Agenda for 103rd PCC Meeting

Date: 17.06.2021
Eastern Regional Power Committee
14, Golf Club Road, Tollygunge
Kolkata: 700 033

**AGENDA FOR 103RD PROTECTION SUB-COMMITTEE MEETING TO BE HELD
ON 17.06.2021 AT 10:30 HOURS**

Figure 1: Step 1 fault calculation 1

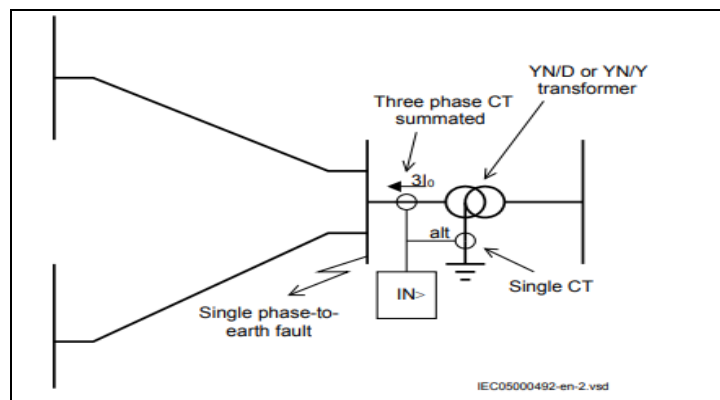
- A.** The primary requirement for the stage 1 setting should be to detect earth faults at the local bus bar, where the transformer winding is connected. Therefore, a fault calculation should be made as per figure 1. This calculation provides the current fed to the protection i.e. $3I_{0\text{fault1}}$. To assure that step 1 calculation to have selectivity for other earth-fault protection in the network, a short delay may be selected. Normally, a delay in the range of 0.3 – 0.4 s is appropriate under such conditions.

Figure 2: Step 1 fault calculation 1

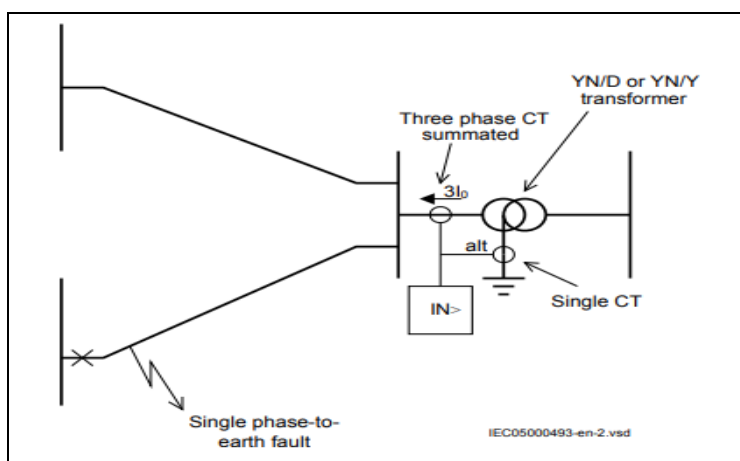
Further to ensure selectivity to delayed line faults clearance at the local bus (typically distance protection operation in zone 2 in 0.5 sec), the current setting must be set high enough so that these faults do not result in unwanted step 1 trip of transformer on earth fault stage 1 setting.

Therefore, a fault calculation as shown in figure 2 is also required to be done. If the fault is located at the borderline between the instantaneous and delayed operation of the line protection (such as Distance protection or line residual overcurrent protection), the above calculation gives the current fed to the protection i.e. $3I_{0\text{fault}2}$ the setting of step 1 can be chosen within the interval shown relation given below for the above calculations.

$$3I_{0\text{fault}2} \cdot \text{lowmar} < I_{\text{step1}} < 3I_{0\text{fault}1} \cdot \text{highmar}$$

Where **lowmar** is a margin to assure selectivity (typical 1.2) and **highmar** is a margin to assure fast fault clearance of busbar fault (typical 1.2)

Non operation of Auto reclose from Sagardighi end for Faults in 400 kV Gokarno -Sagardighi -II :
 Tripping on 04th April 17:29 Hrs(Sagardighi end DR):

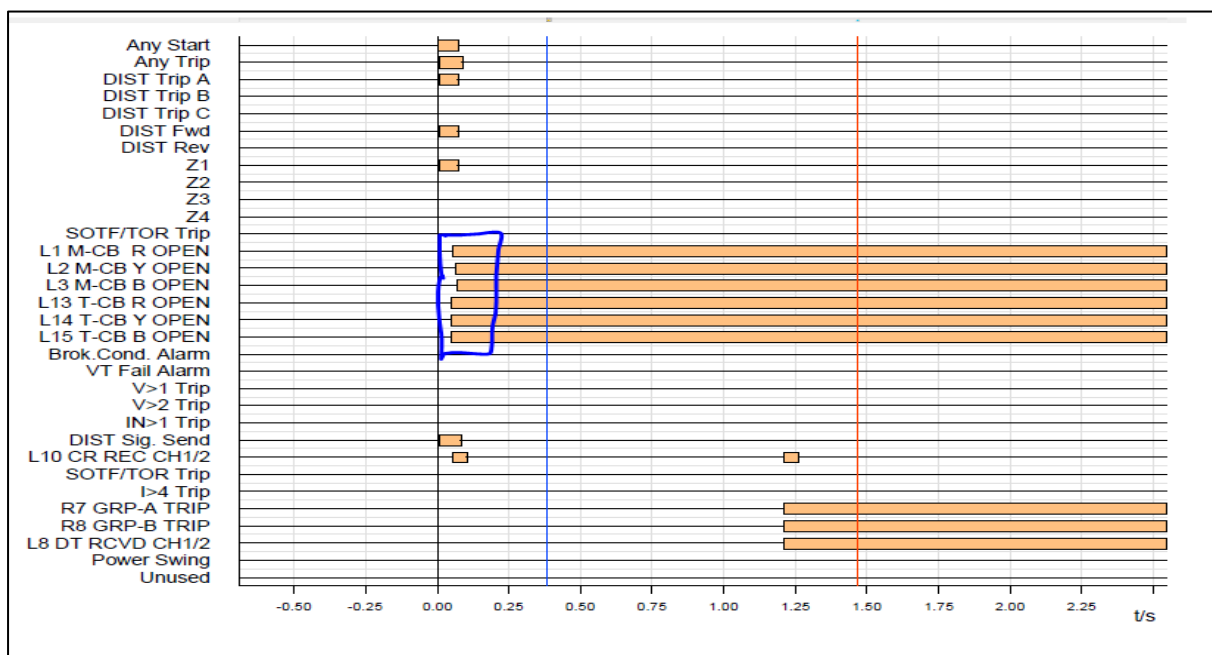
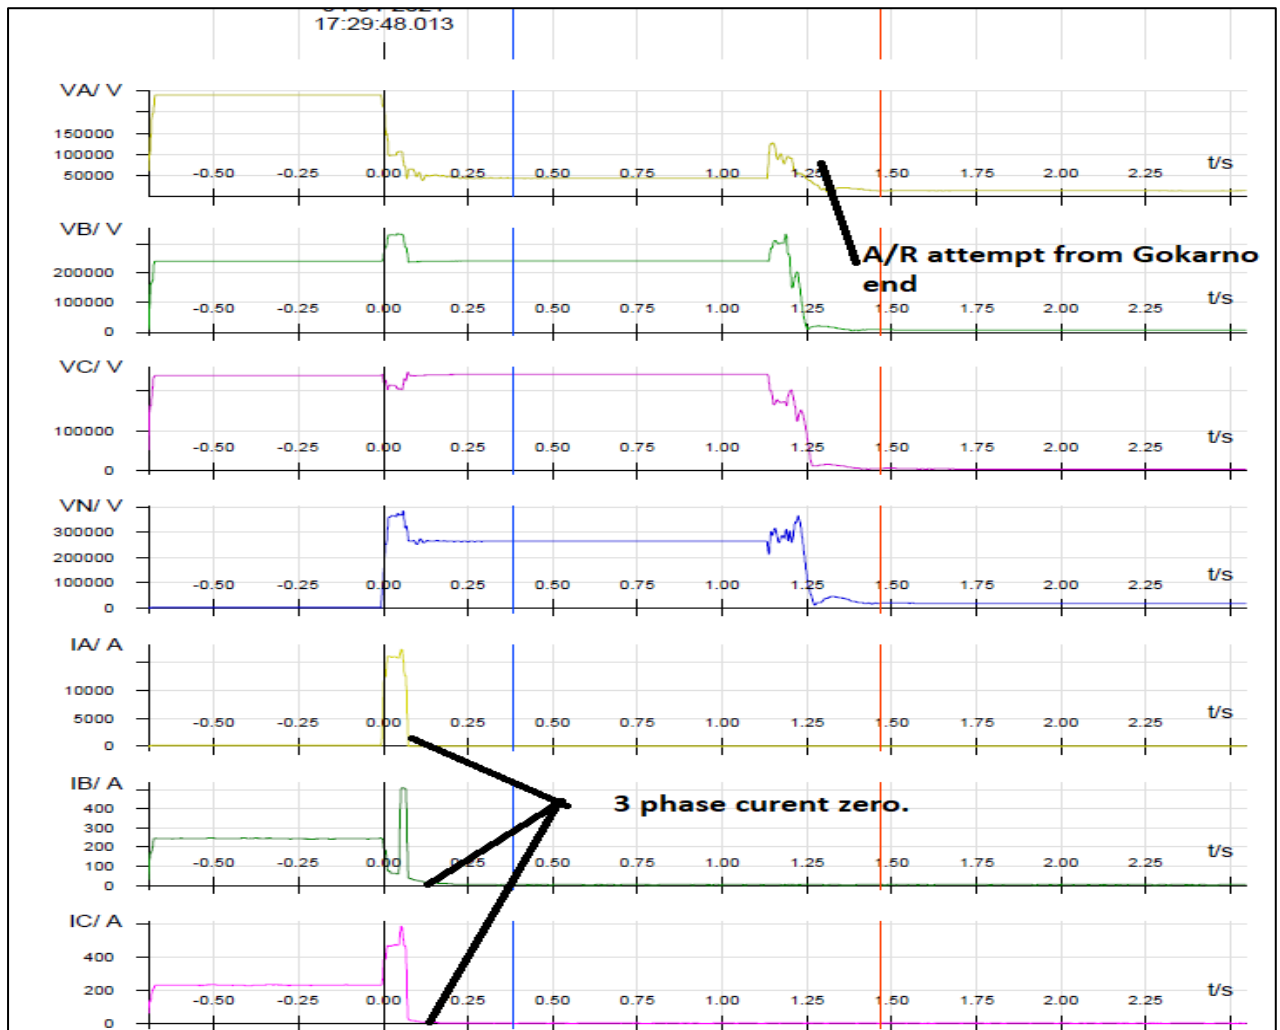
- Healthiness of this transmission lines
- Non-operation of Autoreclose from Sagardighi end
- Non-receipt of DR/EL from Gokarna end

DR at Sagardighi End for Tripping on 11/05/2021 at 12:30 Hrs:

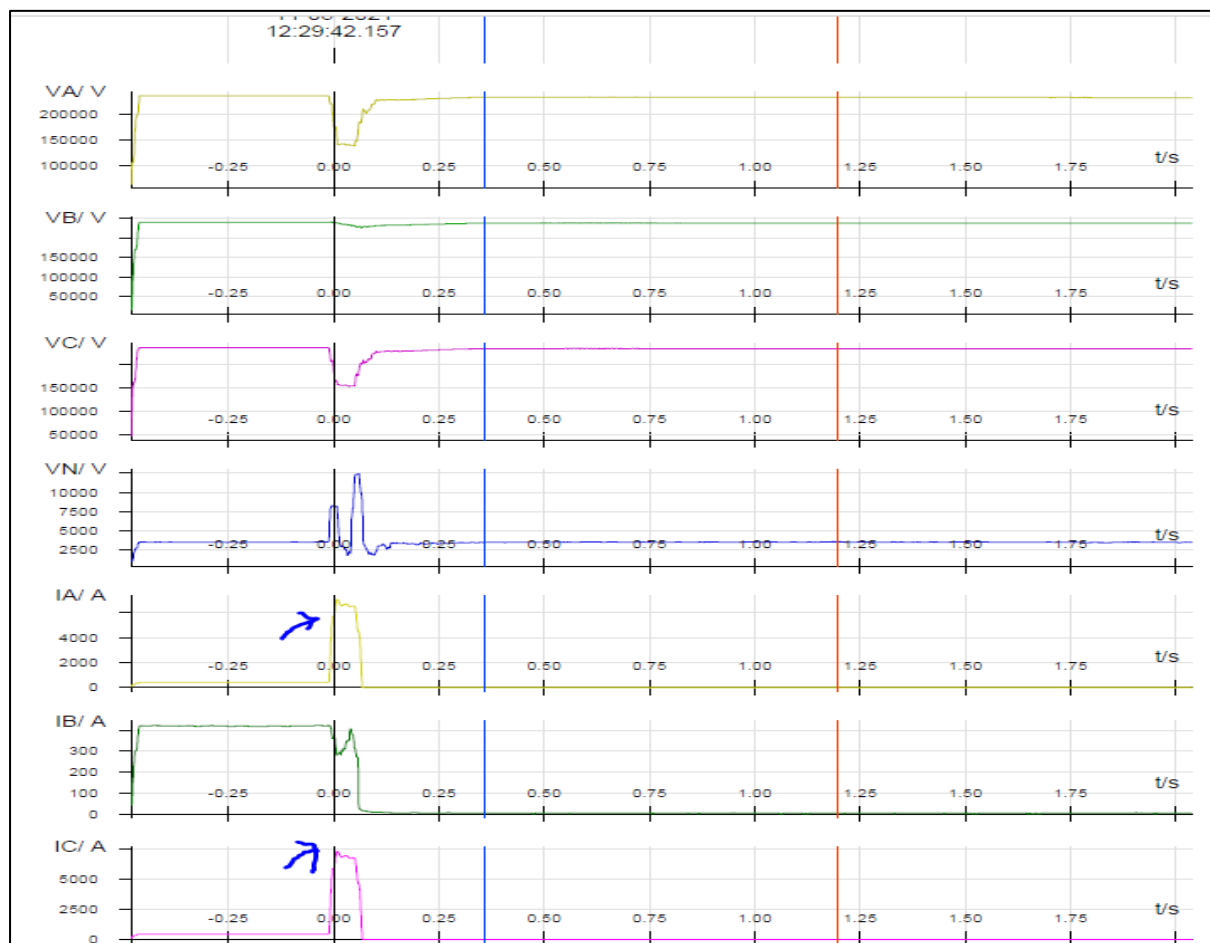
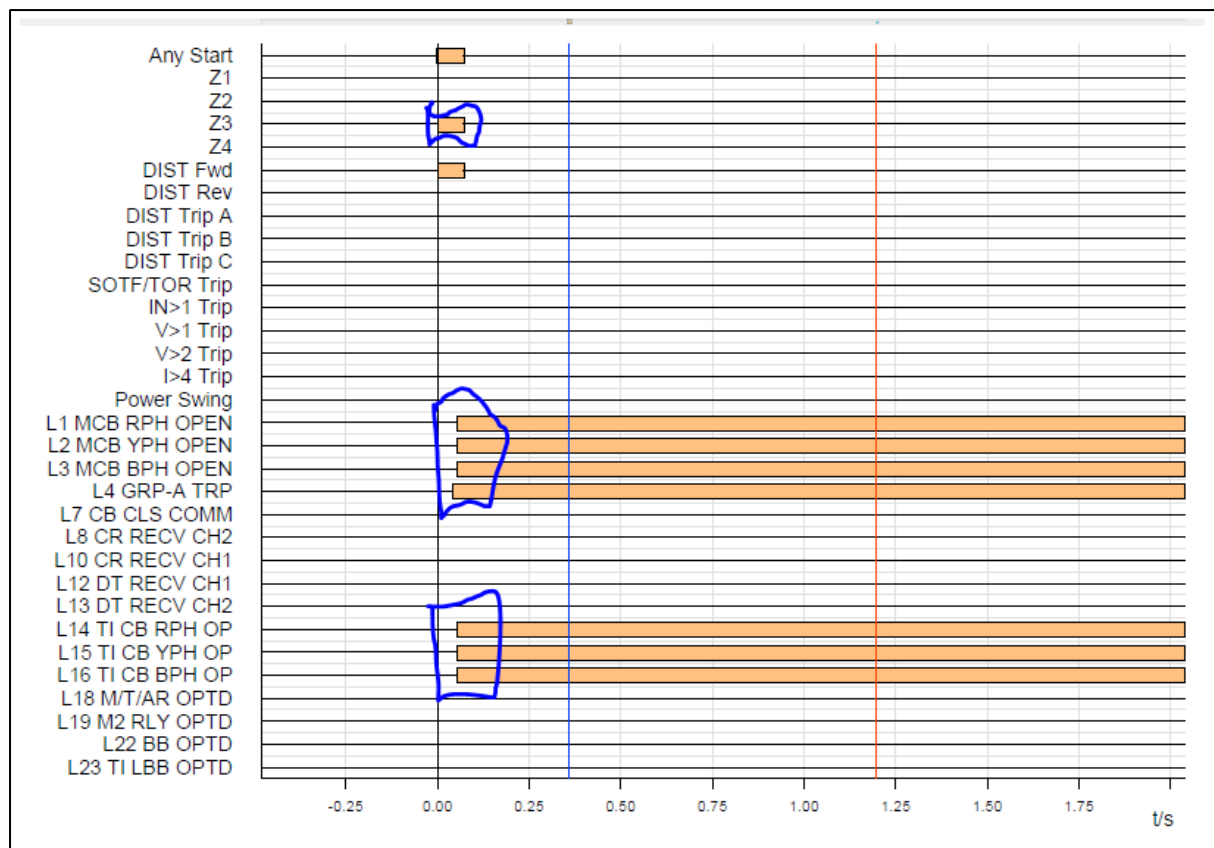
It has been observed that from Sagardighi end this line tripped , on 2 occasions sensing the fault of some other line , in Zone-3 instantaneously ,without delay ,while line was holding from Behrampur end .This is causing un necessary tripping of line and reducing the reliability of system .Root cause may be identified and mitigated as soon as possible.

400KV-BAHARAMPUR-SAGARDIGHI-1	11-05-2021	12:30	Tripped from sagrdighi end only.R-B, Zone-3	Some other line fault was sensed in zone-3 from sagardighi end and ,3 phase tripped immediately from sagardighi end , No tripping from behrampur end.
400KV-BAHARAMPUR-SAGARDIGHI-1	21-04-2021	18:54	Tripped from sagrdighi end only. Zone 3, y-b, If(Y) 3.09KA, If(B)2.9KA. location 171.1km	Some other line fault was sensed in zone-3 from sagardighi end and ,3 phase tripped immediately from sagardighi end , No tripping from behrampur end.

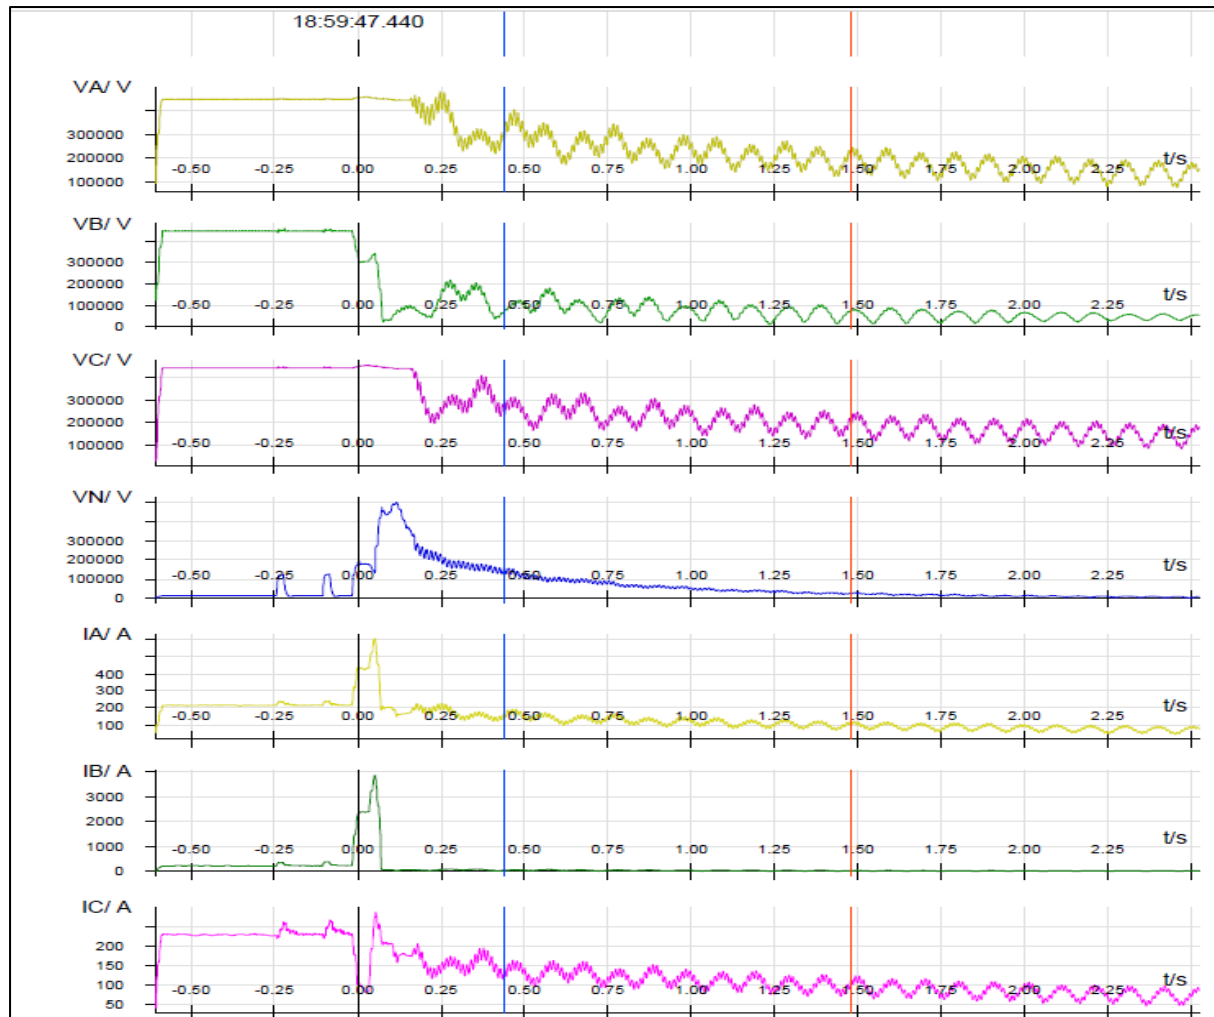
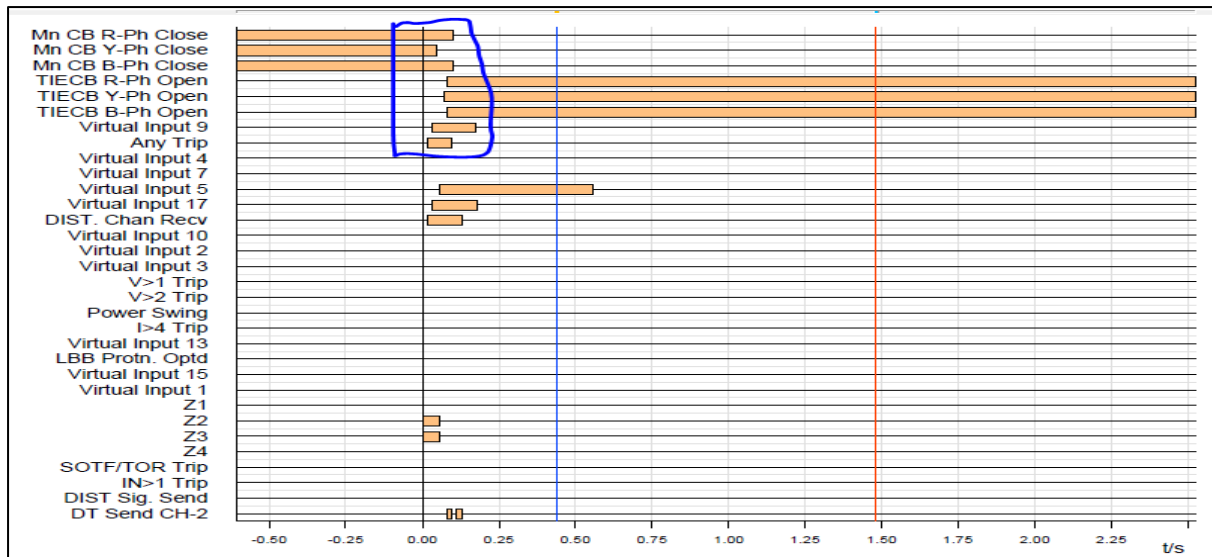
It has been observed from DR that in all the above tripping incidents, there was no Auto reclose attempt from New Ranchi end and 3 phase tripping occurred instantaneously at the instant of fault. Whether A/R is disabled or anti-theft setting is there inadvertently. Root cause may be found and mitigated.

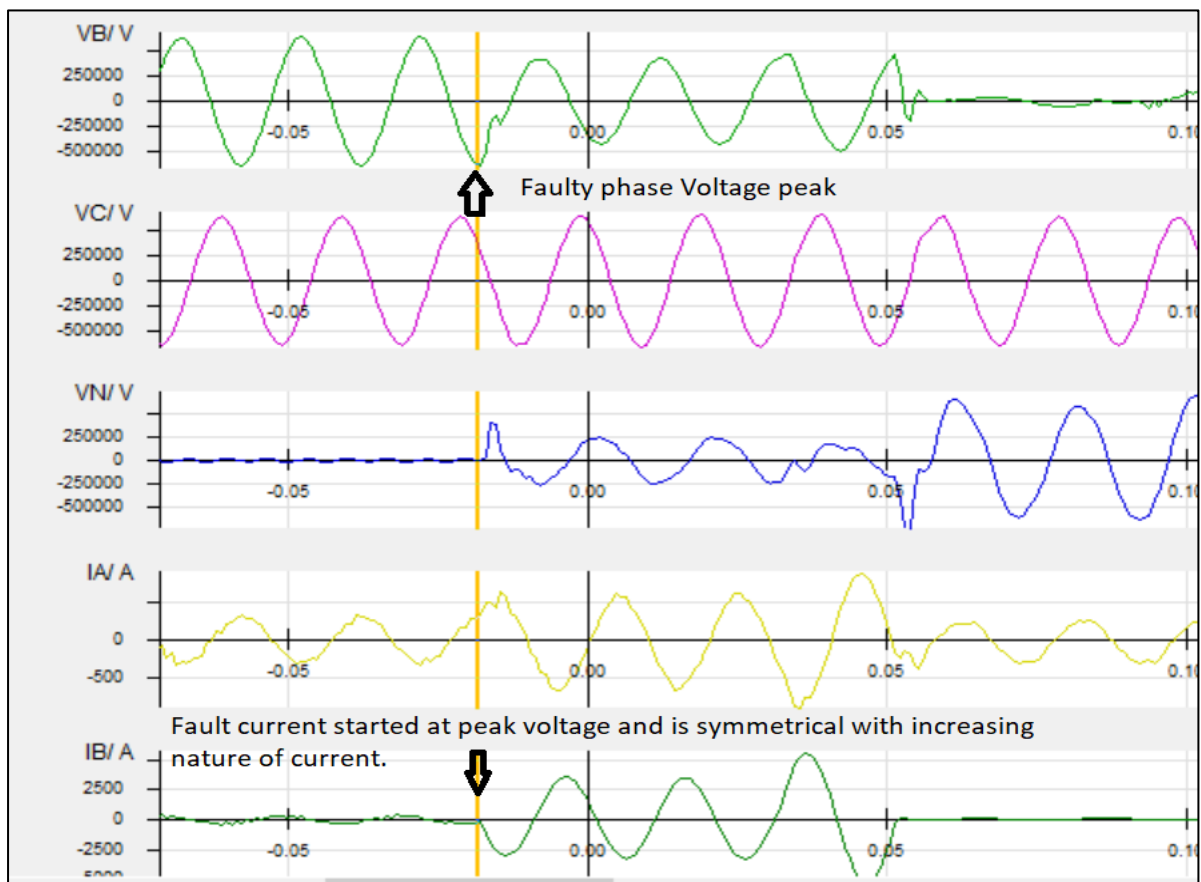
From DR signature analysis it is observed that fault seems to be due to vegetation issue as all faults are occurring at voltage peak as arc over is occurring at voltage peak due to high electrical stress. Fault currents are symmetrical and have no Dc offset due to vegetation fault occurring at peak and with increasing nature of current.
